SUNDRY NOTICES AND REPORTS ON WELLS

Well Name: West Shugart 29 Federal 4		Field: West Shugart Delaware	
Location: Sec 29-T18S-R31E, 822' FSL & 2310' FWL		County: Eddy	State: NM
Elevation: 3584' Casing Head		Spud Date: 7/21/00	Compl Date: 8/24/00
API#: 30-015-30870	Prepared by: Ronnie Slack	Date: 11/17/04	Rev:

Permanent Abandonment of Federal Wells
Conditions of Approval

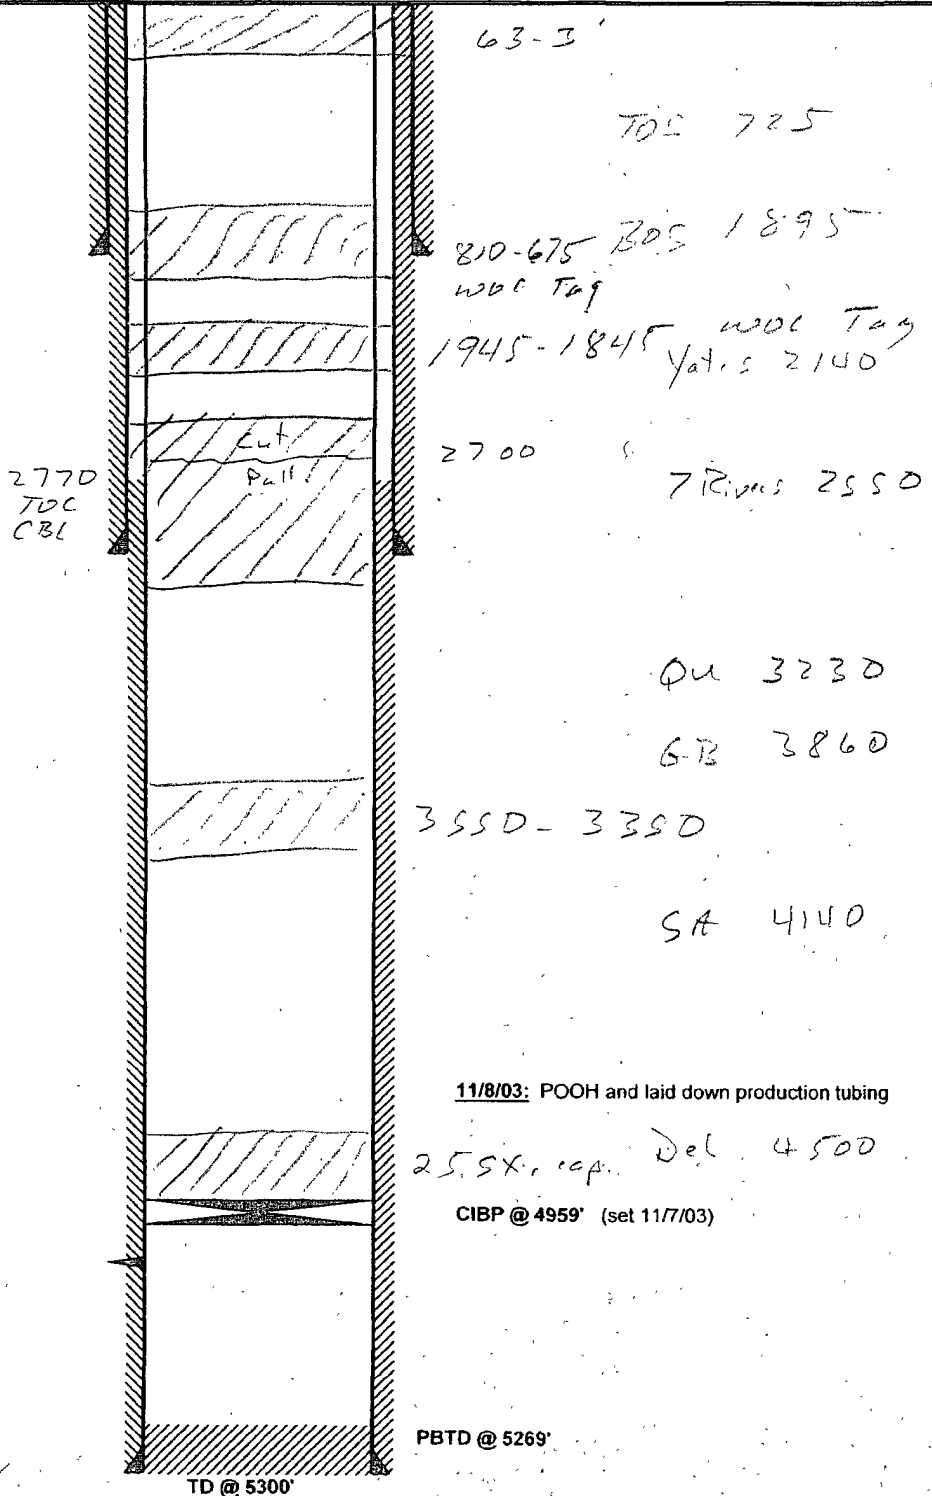
- *1) TAG EXISTING CIBP @ +/-4,959; MIX & PUMP A 25 SX. CMT. PLUG ON TOP OF CIBP; CIRC. WELL W/ PXA MUD.
2) MIX & PUMP A 25 SX. CMT. PLUG @ 3,550'-3,350'; WOC & TAG TOP OF CMT. PLUG. Not Required
3) CUT & PULL 5-1/2" CASING @ +/-2,700'.
4) MIX & PUMP AN 80 SX. CMT. PLUG @ 2,855'-2,650' (8-5/8" CSG. SHOE/5-1/2" CSG. CUT); WOC & TAG CMT. PLUG.
5) MIX & PUMP A 40 SX. CMT. PLUG @ 810'-710' (13-3/8" CSG. SHOE); WOC & TAG CMT. PLUG. Top of Salt
6) MIX & PUMP A 20 SX. CMT. SURF. PLUG @ 63'-3'.
7) DIG OUT & CUT OFF WELLHEAD 3' B.G.L.; WELD ON STEEL PLATE & DRY HOLE MARKER.
1) Mix & Pump adequate cmt to fill from 4959-4450 (Top of Del)
9a) Add plug from 1945-1845 (Base of Salt) WOC Tag
